SAN FRANCISCO PLANNING DEPARTMENT

MEMO

DATE: September 14, 2016
TO: Architectural Review Committee of the Historic Preservation Commission
FROM: Eiliesh Tuffy, Historic Preservation Technical Specialist, (415) 575-9191
REVIEWED BY: Tim Frye, Historic Preservation Officer, (415) 575-6822
RE: **Review and Comment: Teatro ZinZanni**
Case No. 2015-016326COA

ZinZanni / Kenwood - The Theater & Hotel @ Broadway | San Francisco, California

Broadway Elevation

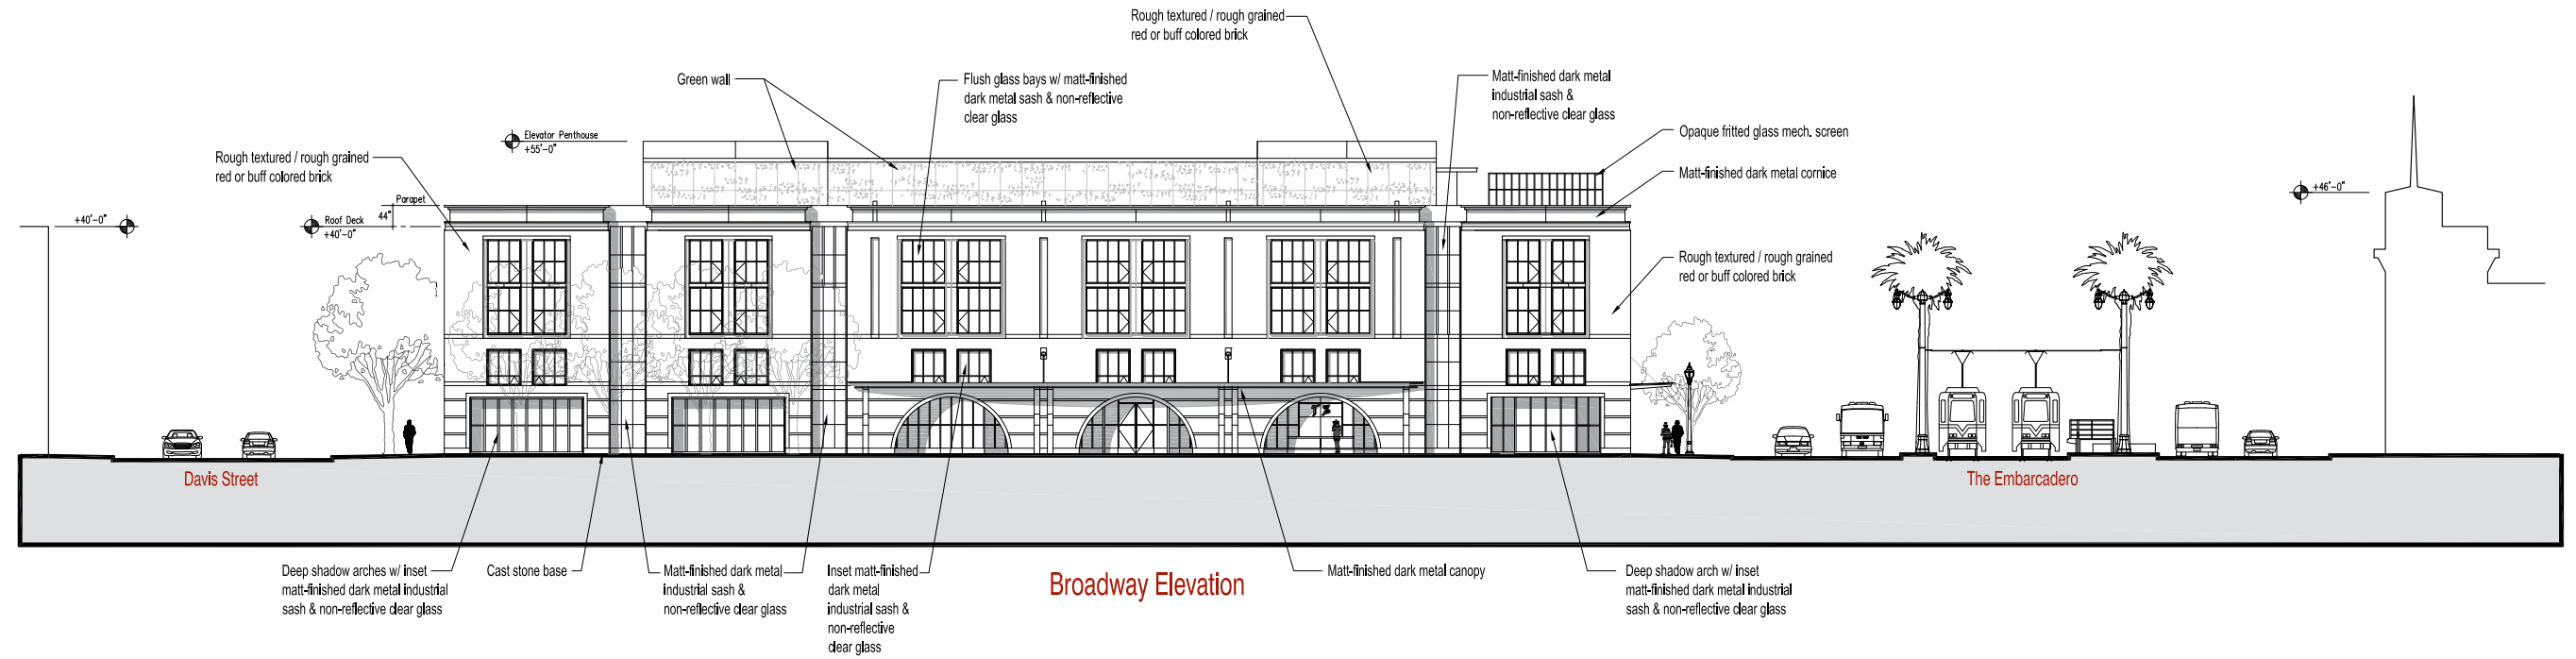
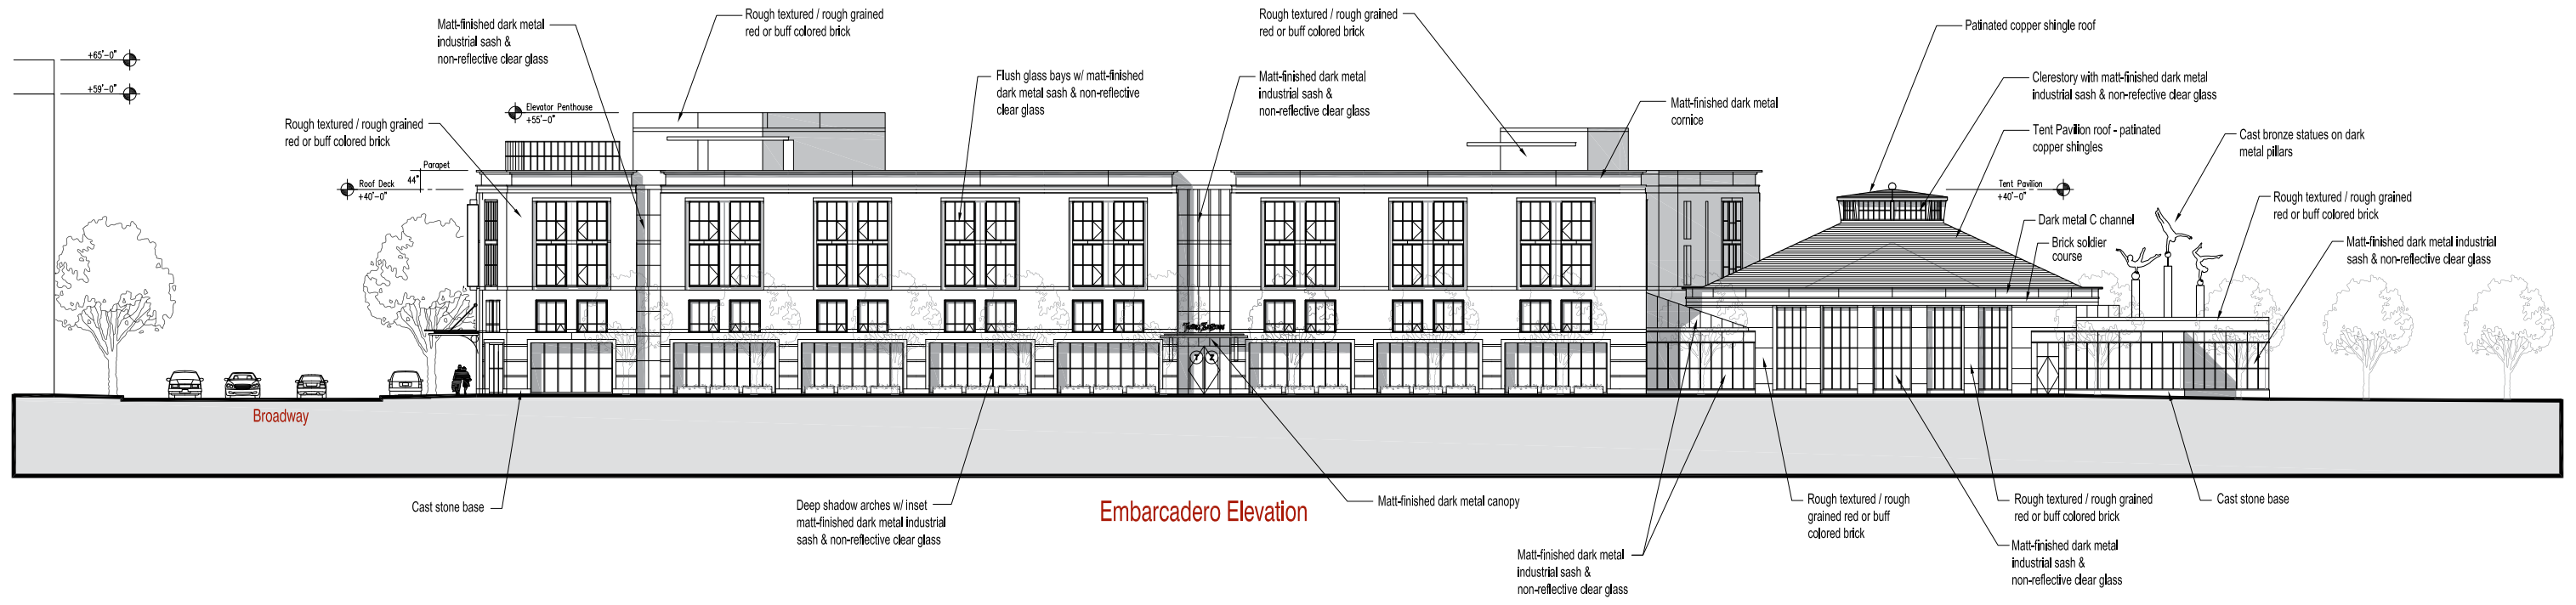
The continuity of the façade and overall sense of large bulk is disrupted by the introduction of full-height glazed setbacks. As proposed, the glazed vertical breaks in the façade do not reference character-defining fenestration in the district such as industrial steel sash windows. Also, the only instance of a contemporary glass bridge connector is over Icehouse Alley, where one was approved in 1992 as a cross-alley link between two

separate buildings. Therefore full-height, glazed portions of the façade should be limited to applications such as a possible connector between the hotel and theater building, or in applications where it would aid in the creation of pedestrian-level visual connections to the Embarcadero.

The design proposes a recessed, 3-bay arcade on the Broadway elevation and a recessed ground floor corner at Broadway & The Embarcadero, in conflict with Section 7(b)1 of the designating ordinance. The Department recommends removal of the nonconforming Broadway arcade in favor of a primary building entrance more in keeping with those found on contributing buildings in the district. Often primary building entrances are identified through more ornate treatment of the cladding material at the entrance surround. The building corner at Broadway and The Embarcadero has a high level of public visibility due to its proximity to a wide intersection. Historic buildings in the district have strong building corners that solidly meet the ground. The proposed recess at the base of the building corner should be removed, as it creates an arcade condition in conflict with Section 7(b)(1) of the ordinance and is out of character with the district.

While large openings are common on the ground floor of historic warehouses and industrial buildings, they typically have lintels that are either flat or slightly arched. Arches that spring from grade level, and recessed arcades are not characteristic of the district. The design of the ground floor fenestration should eliminate the full-height arches, incorporate a compatible lower bulkhead design and remove any exterior arcades from the floor plan to adhere to Section 7(b)1 of the designating ordinance. Window sashes, if drawing from the industrial-style fenestration in the district, should have muntin patterns and operating mechanisms compatible with historic industrial doors and windows found in the district.

Wall Section

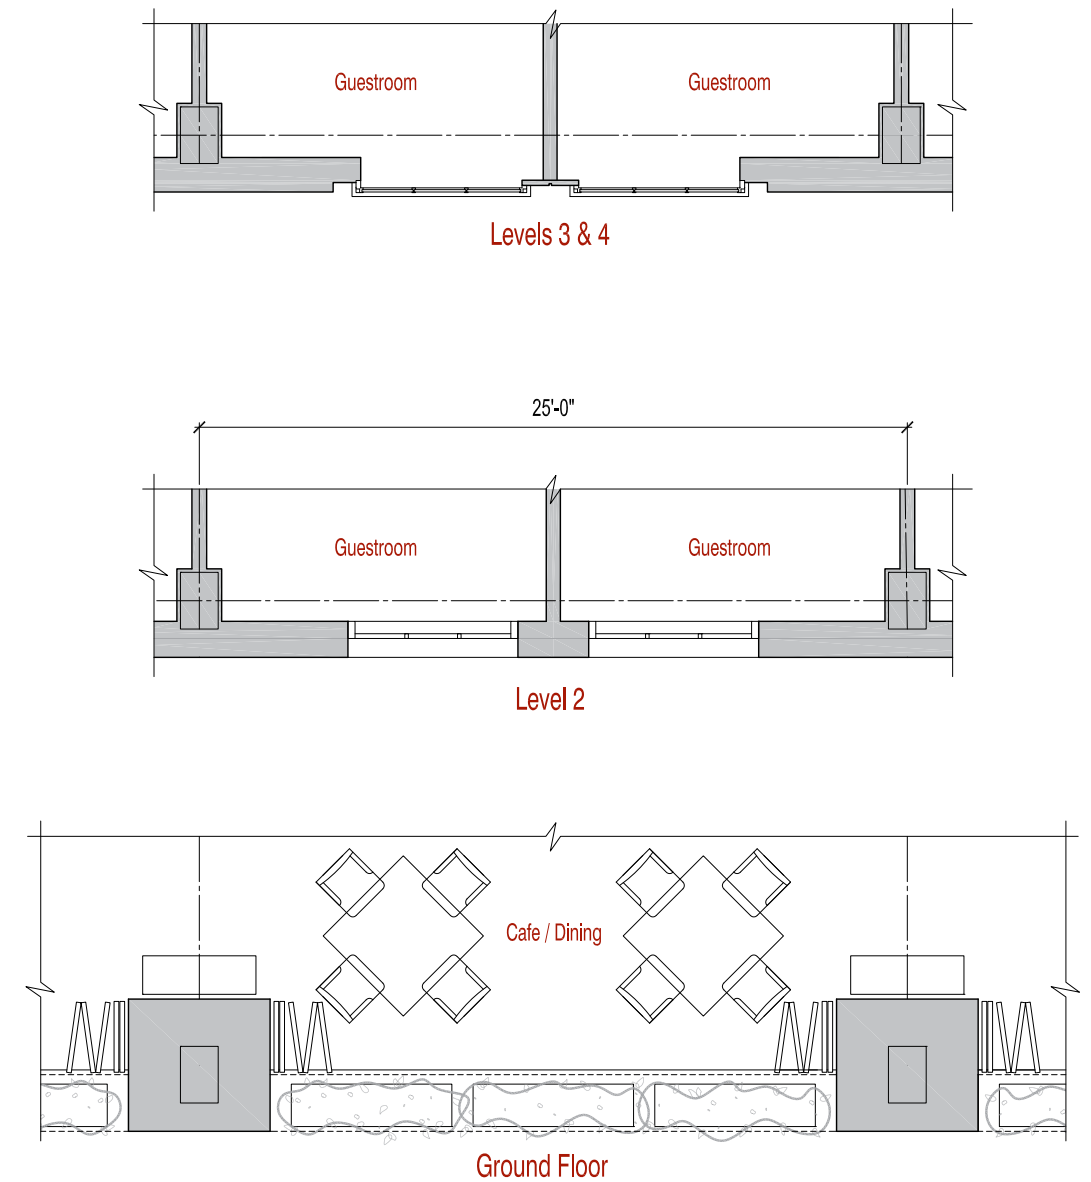
The highly visible metal safety railing was determined to be an incompatible design treatment and material for a rooftop parapet in the district. Brick and stucco, the two major building materials identified in the ordinance, were used for parapet walls and cornices, as a continuation of the exterior building cladding. The proposed rooftop parapet should be either brick or stucco, consistent with the final exterior wall cladding material, and should be finished in a form and profile that relates to historic cornices in the district such as an outward-projecting profile with corbel or dentil detailing.

Building Elevations - Planning Department Alternate

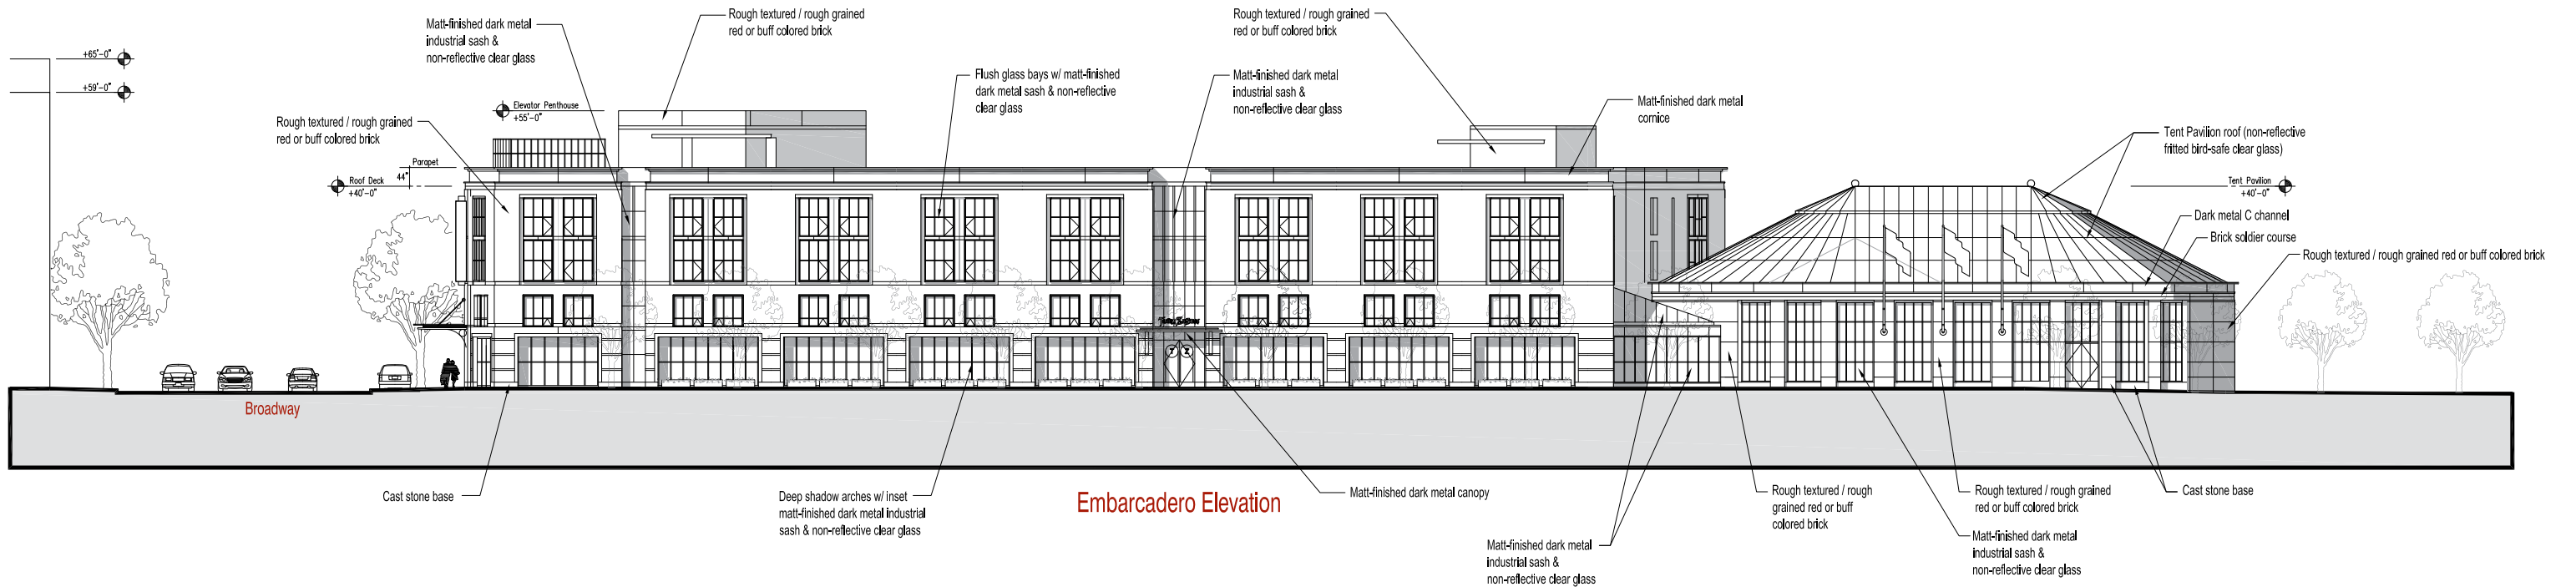
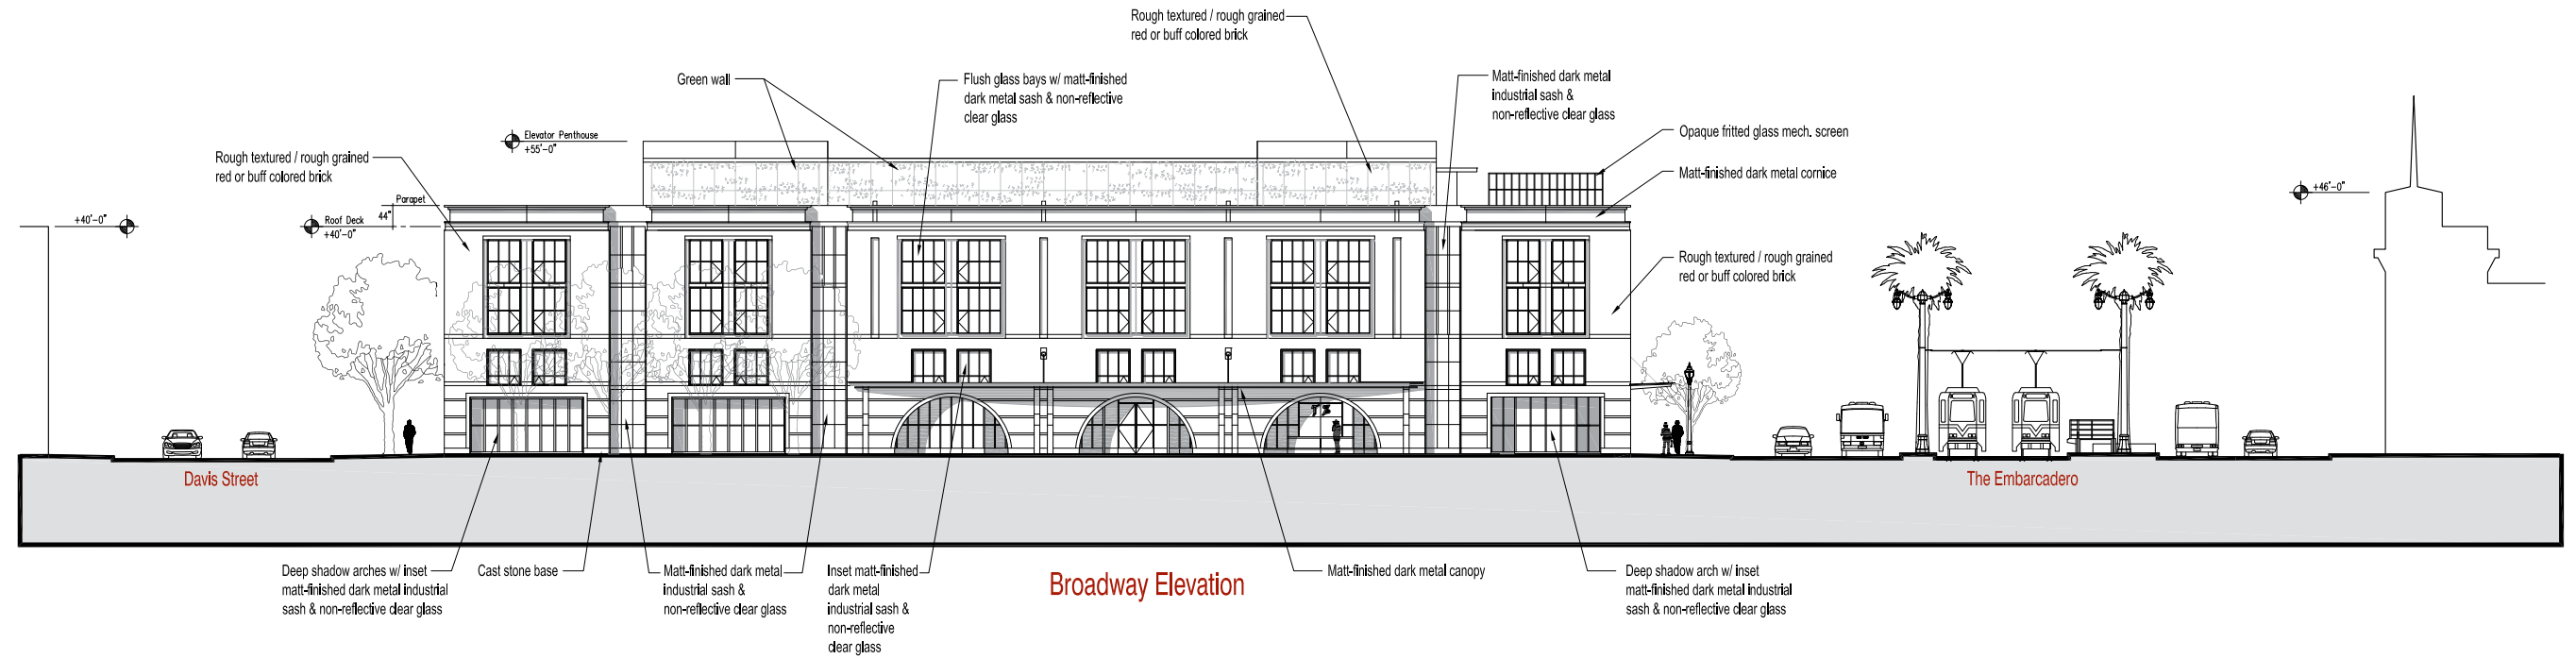
The sponsor's submittal includes an alternate design for a glass roof on the theater building (see the "Alternate Studies" section, pages 43-49). A glass roof would further differentiate the theater as new construction, however it could result in greater levels of rooftop illumination than that of the copper-shingle roof proposal.
